Discussion on recent m_{top} measurement in $l+jets$ final states at DØ for Tevatron combination

Oleg Brandt (U Heidelberg)

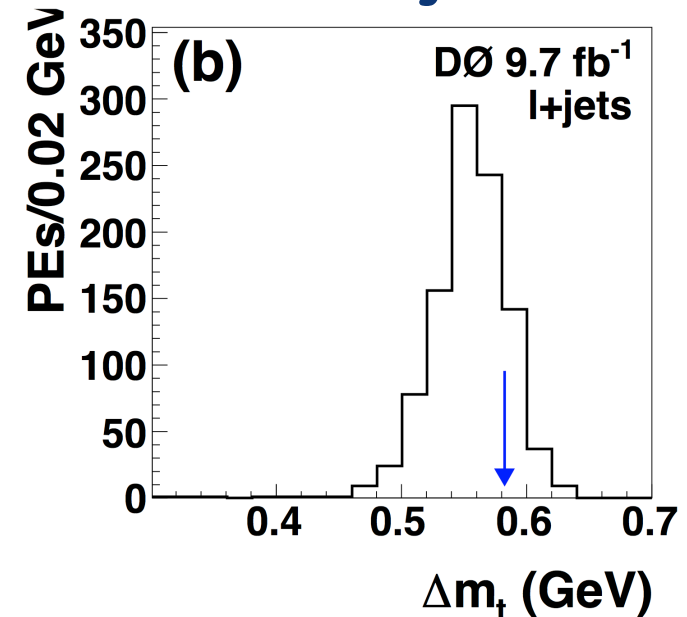
- **2. Stat uncertainty is about 20% lower than expecting from 3.6/fb analysis and CDF ME analysis if rescaled with the luminosity. Any explanation?**
- **→ This is due to a slightly lower signal fraction in Run IIb1:**

Epoch	Channel	Signal fraction	$\sigma_{t\bar{t}}$ (pb)
Run IIa	e +jets	0.72	8.9
	μ +jets	0.65	7.8
Run IIb1	e +jets	0.77	7.6
	μ +jets	0.66	6.8
Run IIb2	e +jets	0.68	7.8
	μ +jets	0.66	7.5
Run II3+4	e +jets	0.56	7.6
	μ +jets	0.75	8.0
Run II	e +jets	0.63	7.8
	μ +jets	0.70	7.6

- We checked explicitly for Run IIa:
 - $\Delta m_t^{\text{old}} = 1.76 \text{ GeV}$
 - $\Delta m_t^{\text{new}} = 1.88 \text{ GeV}$
- For Run IIb1:
 - $\Delta m_t^{\text{old}} = 1.28 \text{ GeV}$
 - $\Delta m_t^{\text{new}} = 1.16 \text{ GeV}$ (rescaling Run IIb1 to 2.6 fb^{-1})
- What matters is that the measured uncertainty is consistent with the expectation:
